TRC AGENDA

**CITY OF DELAND
THURSDAY SEPTEMBER 21, 2023 AT 1:30 P.M.
CITY OF DELAND TRC MEETING ROOM
DELAND, FLORIDA**

**CITY OF DELAND
TECHNICAL REVIEW COMMITTEE MEETING
MEETING MINUTES
THURSDAY, AUGUST 17, 2023 -1:30 P.M.
CITY HALL**

City of DeLand
SP23-185
CULVER'S

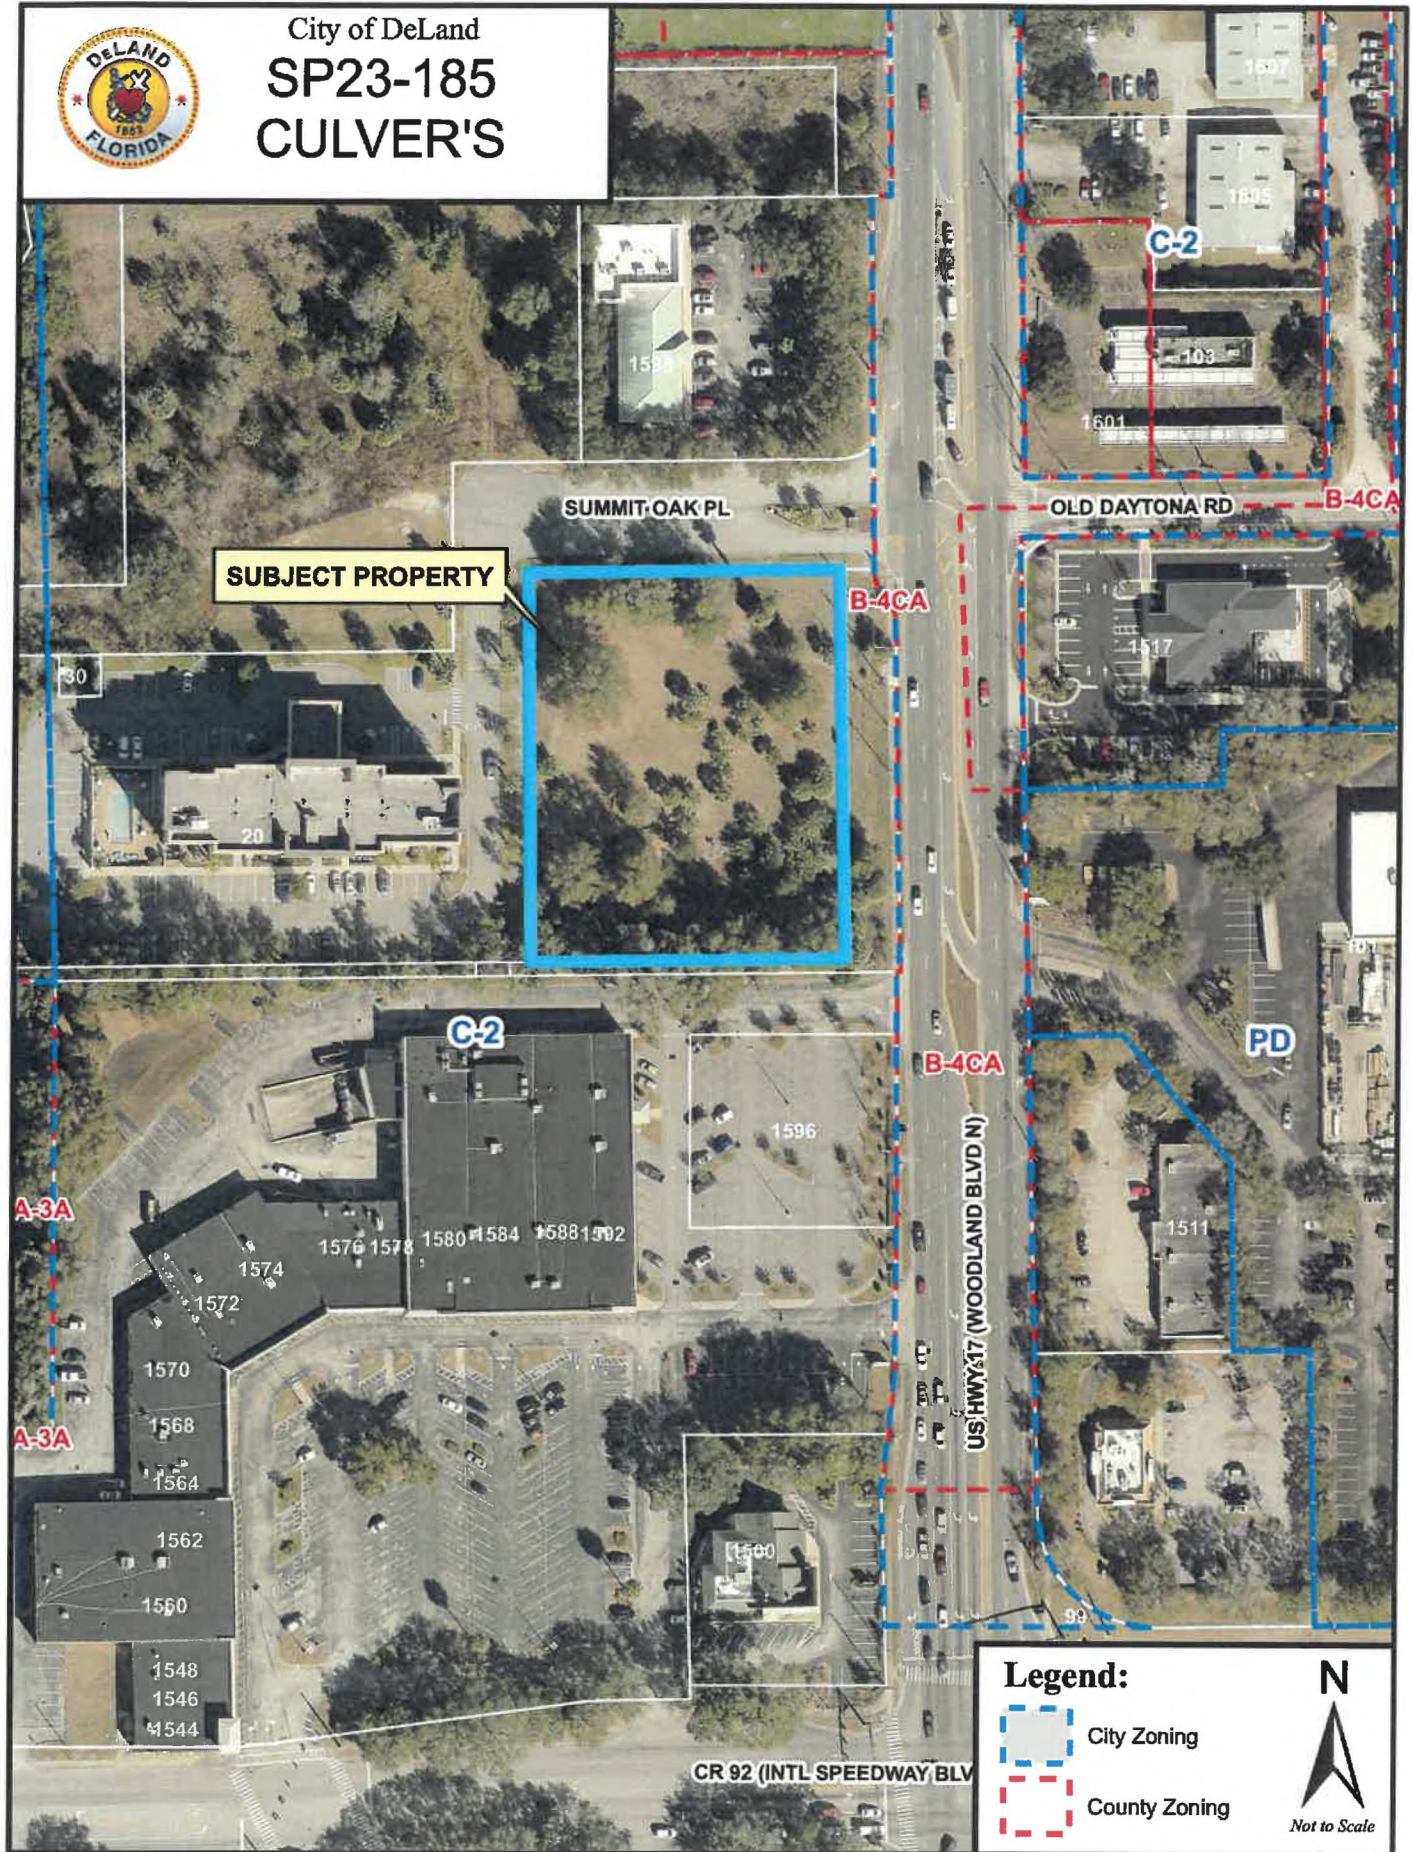
Discipline	Status	Details	Attached To	Created By	Last Updated By	Modifications Required
Pavement details						
Engineering	Draft	1. There are two details shown on this sheet. One for "Typical Pavement Section" and the other one for "Concrete Pavement". Which one will be used for all paving areas?	C4	Ray Bahrami	Ray Bahrami	Yes
Runoff						
Engineering	Draft	1. Does additional stormwater runoff from FDOT Right-of-way area discharge to this development on the east side?	C3	Ray Bahrami	Ray Bahrami	Yes
Cross section and roof drain						
Engineering	Draft	1. Please provide two cross sections from northern property line to southern property line and another one from east to west which includes proposed building. 2. Roof drain proposed cleanouts top and invert elevations need to be included in the plan.	C3	Ray Bahrami	Ray Bahrami	Yes
CO Top						
Engineering	Draft	1. Please provide top elevation for all proposed cleanouts.	C2	Ray Bahrami	Ray Bahrami	Yes

Handicapped Parking and overhang						
Engineering	Draft	1. Handicapped parking is required to be 20' long by 12' wide. 2. The proposed 5' sidewalk in front of the building (north side) either needs to be increased to 7' due to vehicle overhang or new wheel stops need to be installed.	C1	Ray Bahrami	Ray Bahrami	Yes
Site Data						
Engineering	Draft	1. Site Data: Are pervious pavers considered as part of pervious area calculations? What is the percolation rate? 2. Please include the percent impervious allowed and what is proposed.	C0	Ray Bahrami	Ray Bahrami	Yes

Discipline	Status	Details	Attached To	Created By	Last Updated By	Modifications Required
Geotechnical Report						
Engineering	Draft	1. The reviewer cannot locate a copy of geotechnical report for this development which contains parking lot pavement recommendation.		Ray Bahrami	Ray Bahrami	Yes
Storm sewer design						
Engineering	Draft	1. Please provide storm sewer design calculations to make sure existing 18" storm pipe in Hampton Inn parking lot where this development's storm sewer pipes are connected to, can handle it. 10Yr- 24Hr storm event will need to be used for existing pond tailwater elevation.		Ray Bahrami	Ray Bahrami	Yes
Stormwater Statement						
Engineering	Draft	1. Stormwater Statement, Proposed Conditions: Modified stormwater permit for Applebee's needs to be submitted and reviewed by Engineering for approval.		Ray Bahrami	Ray Bahrami	Yes
Permit						
Engineering	Draft	1. Since this project is adjacent to FDOT Right-of-Way, a FDOT Permit may be required.		Ray Bahrami	Ray Bahrami	Yes

Fire Hydrant						
Fire	Draft	Fire Hydrant will need to be added on property.	C2	Jamie Lunsford	Jamie Lunsford	Yes
Tree Placement						
Forestry	Draft	There are several trees that the planting locations look like they could be moved away from the curb/asphalt and storm drains. Putting more distance between the trees to be planted and the curbs and storm drains, would reduce the future impact of the roots.	L-2	Kit Dennis	Kit Dennis	Yes
37" Laurel Oak						
Forestry	Draft	You are proposing to save a 37" Laurel Oak that appears to be less than 10' from where a curb will be installed. This species of tree does not respond well to construction damage. Being that it is likely near the end of its life span, and its proximity to the drive through lane, you may want to consider removal and replacement of this tree.	L-1	Kit Dennis	Kit Dennis	Yes
Silt Fence Vs. 37" Laurel Oak						
Forestry	Draft	Please consider modifying the silt fence around the 37" Laurel Oak that is being proposed as being preserved.	C3.1	Kit Dennis	Kit Dennis	Yes

Forestry	Draft	We recommend running the Tree Barricade along the edges of the buffer areas rather than around each tree.	L-1	Mariellen Calabro	Mariellen Calabro	Yes
		Tract "E"				
Forestry	Draft	Change the text to read that "Tree Preservation Tract "E" satisfies the Tree Protection Area Requirements for this parcel." It does not satisfy the Tree Mitigation Requirements. Please also provide the square footage of Tract "E."	L-1	Mariellen Calabro	Mariellen Calabro	Yes
		Tree Barricade Detail				
Forestry	Draft	Update with the 2023 version that can be found on our website.	L-1	Mariellen Calabro	Mariellen Calabro	Yes
		Trees less than 6" DBH				
Forestry	Draft	Trees less than 6" DBH do not need to be included in your calculations. This should change your trees to be removed from 817" DBH to 802" DBH. Your replacement requirement for removing these trees will be 267" DBH.	L-1	Mariellen Calabro	Mariellen Calabro	Yes

Planning	Draft	Upward Illumination Please confirm all upward lighting meets the criteria of Sec. 33-94.03 (g). Please provide additional information on the photometric plan to ensure compliance with the following. 9.All lighting shall be downward and of the full cut off shield variety in which the light source is recessed and shielded in a manner which prohibits upward light overspill into the night sky. Upward illumination is prohibited except: a. Ground level light fixtures, which shall be of the burial vault type and shall be fully screened by landscaping. Illumination from ground level light fixtures shall not exceed the roof line of the illuminated structure by greater than 0.01 foot-candles. b. Illumination from building wall lights providing architectural detail where a component of the lighting is designed to illuminate the building in an upward manner as part of the building aesthetic design shall not exceed the roof line of the illuminated structure by greater than 0.01 foot-candles.	A4	Samuel Nelson	Samuel Nelson	Yes

Discipline	Status	Details	Attached To	Created By	Last Updated By	Modifications Required
		Illumination from any light source onto adjacent properties or into the public right-of-way shall not exceed 0.5 foot-candles. Many areas around the property appear to exceed this requirement. 33-94.03 (g) Lighting 2. Off-site areas shall be shielded from offensive or excessive illumination. Illumination from any light source onto adjacent properties or into the public right-of-way shall not exceed 0.5 foot-candles.				
Planning	Draft	Bicycle Parking Please include the # of bicycle parking spaces is the parking provided area.	C0	Samuel Nelson	Samuel Nelson	Yes
Planning	Draft	ADA Parking ADA parking spaces are required to be 12' x 20'. Additionally, if these spaces are made conforming the drive aisle width would be reduced under the minimum required 24' width. 33-91.06 (b) 6. Spaces for handicapped parking shall measure 12 feet wide by 20 feet long and shall be located adjacent to handicap access ramps.	C1	Samuel Nelson	Samuel Nelson	Yes

Planning	Draft	LED Strip Lighting Strips of LED Lighting are prohibited without staff approval, 33-73.02 (f) Strings of light bulbs, continuous neon borders, neon highlighted signs/graphics or other lighting borders, draping, wrapping or similar decorative lighting display used on commercially developed parcels for commercial purposes, other than traditional holiday decorations, are prohibited without staff approval.	A4	Samuel Nelson	Samuel Nelson	Yes
Planning	Draft	Exterior Wall Mounted Lighting Please show any exterior wall mounted lighting on the photometric plan and update the photometric plan to include this wall mounted lighting.	SL1	Samuel Nelson	Samuel Nelson	Yes
